ADMINISTRATION REPORT **REZONING** CALGARY TRAIL NORTH

4607 - Calgary Trail NW and 4710 - Gateway Boulevard NW

Recommendation: That **Charter Bylaw 19992** to amend the Zoning Bylaw from (DC2.986) Site Specific Development Control Provision to (DC2) Site Specific Development Control Provision be **APPROVED**.

PROPOSED DC2 PROVISION SITE PLAN

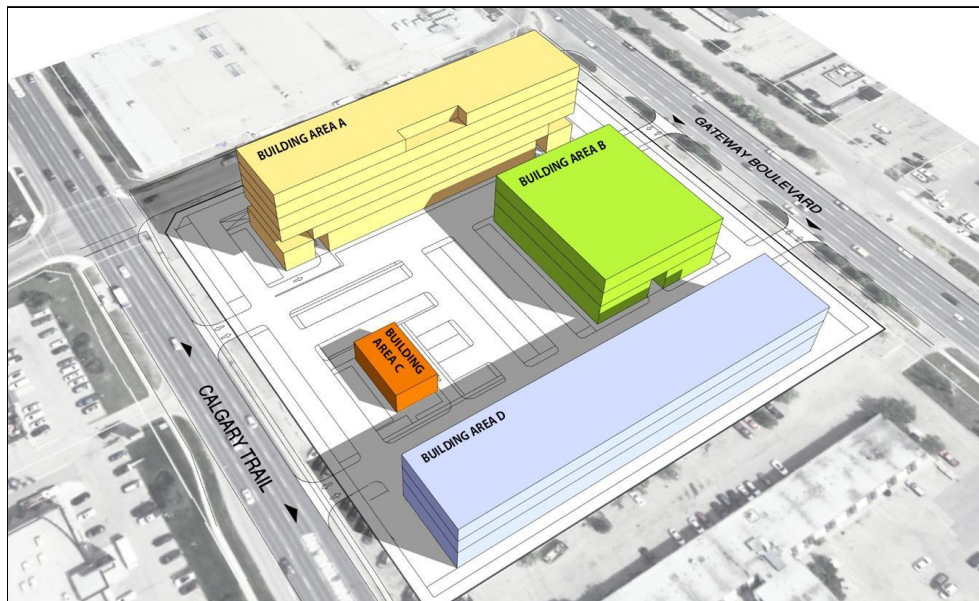
This application was reviewed by the Edmonton Design Committee on October 5, 2021. A recommendation of support was provided with the following conditions:

- Increasing the minimum width of sidewalks (1.5m minimum, 2.0m preferred). Increasing the minimum width of sidewalk frontages at Building B to 3 meters.
- Ensuring design regulations are sufficient to minimize the impact of vehicle overhangs on sidewalks.
- Assessing direct pedestrian connectivity to the corners of 48 Avenue and Calgary Trail/Gateway Boulevard.
- Increasing the frontage dimension when planting adjacent to exterior walls is used to reduce the perceived massings.
- Providing additional greenspaces or a larger central greenspace within the internal areas of the site, including the north /south pedestrian connector. In addition, the central greenspace/refuge island requirements are to be defined in the zoning text.

To address these comments the following modifications were made to the application:

- Regulations within the proposed DC2 Provision were modified to reflect the proposed site plan and overall design intent for the site; and
- Additional regulations were added to enhance and improve pedestrian circulation within the site
